Access Compliance Report

Public Rights-of-Way

(Pedestrian Signals)

Intersection ID: N/A	Main Street:	Cross Street: N/A	Location: N/A
ADA ID: 7C49D63668B4	Signal Type: One Push Button-Non APS	Overall Compliance: No	Severity Score: BTN 1: N/A BTN 2: N/A No BTN: N/A
Codes/Mitigation Info/Possible Solution		Field Measurements/Component Compliance

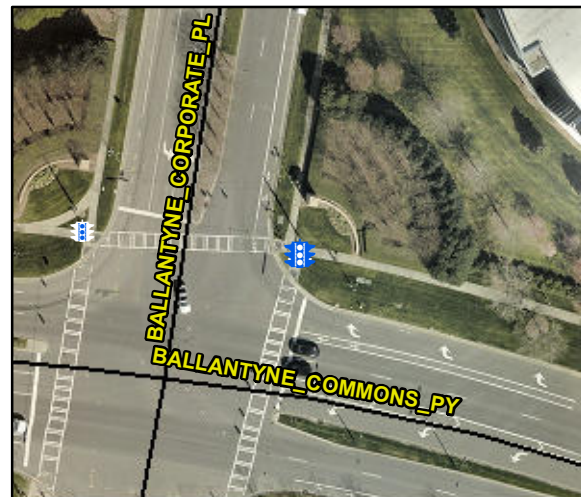
Compliance	Description	Data	Compliance	Description	Data
	Button Count	Button1	N/A	Distant to Additional Button (in)	N/A
	Additional Button Present?	No		Additional Button ID	N/A
N/A	Signal Buttons Required?	N/A	N/A	Additional Ped Posts Required	N/A
	How Many Ped Street Xings?	2		Located In An Island/Median?	No
N/A	B 1 Sign Present?	Yes	N/A	B 2 Sign Present?	N/A
Yes	B 1 Sign Purpose?	Yes	N/A	B 2 Sign Purpose?	N/A
Yes	B 1 Sign Lettering & Contrast?	Yes	N/A	B 2 Sign Lettering & Contrast?	N/A
Yes	B 1 Parallel To XWalk?	Yes	N/A	B 2 Parallel To XWalk?	N/A
Yes	B 1 PAR to Button?	Yes	N/A	B 2 PAR to Button?	N/A
Yes	B 1 PAR to XWalk?	Yes	N/A	B 2 PAR to XWalk?	N/A
Yes	B 1 Clear Floor Space?	Yes	N/A	B 2 Clear Floor Space?	N/A
N/A	B 1 FWD Approach?	Yes	N/A	B 2 FWD Approach?	N/A
N/A	B 1 FWD Approach Constrained?	No	N/A	B 2 FWD Approach Constrained?	N/A
No	B 1 FWD Approach Reach (in)	2.0	N/A	B 2 FWD Approach Reach (in)	N/A

N/A	B 1 FWD Approach Width (in)	N/A	N/A	B 2 FWD Approach Width (in)	N/A
N/A	B 1 FWD Approach Obstruction?	Yes	N/A	B 2 FWD Approach Obstruction?	N/A
N/A	B 1 FWD Approach Obstruction Dist (in)	2.0	N/A	B 2 FWD Approach ObstructionDist (in)	N/A
N/A	B 1 PARA Approach?	Yes	N/A	B 2 PARA Approach?	N/A
N/A	B 1 PARA Approach Constrained?	No	N/A	B 2 PARA Approach Constrained?	N/A
Yes	B 1 PARA Approach Reach (in)	2.0	N/A	B 2 PARA Approach Reach (in)	N/A
N/A	B 1 PARA Approach Width (in)	N/A	N/A	B 2 PARA Approach Width (in)	N/A
N/A	B 1 PARA Approach Obstruction?	Yes	N/A	B 2 PARA Approach Obstruction?	N/A
N/A	B 1 PARA Approach Obstruction Dist (in)	2.0	N/A	B 2 PARA Approach ObstructionDist (in)	N/A
Yes	B 1 Clear Floor Space Slope (%)	6.0	N/A	B 2 Clear Floor Space Slope (%)	N/A
No	B 1 Clear Floor Space XSlope (%)	4.2	N/A	B 2 Clear Floor Space XSlope (%)	N/A
N/A	B 1 PAR Slope (%)	6.0	N/A	B 2 PAR Slope (%)	N/A
Yes	B 1 Height (in)	38.0	N/A	B 2 Height (in)	N/A

Yes	B 1 Clear Xing Direction?	ClearlyMarked	N/A	B 2 Clear Xing Direction?	N/A
	B 1 Crossing Direction	To W		B 2 Crossing Direction	N/A
Yes	B 1 DistanceTo XWalk (in)	0.0	N/A	B 2 DistanceTo XWalk (in)	N/A
No	B 1 DistanceTo Curb (in)	101.0	N/A	B 2 DistanceTo Curb (in)	N/A
Yes	B 1 Diameter (in)	2.0	N/A	B 2 Diameter (in)	N/A

Possible Solutions: Replace Signal Push Button With APS Button on New Post. Remove & Relocate Sign.
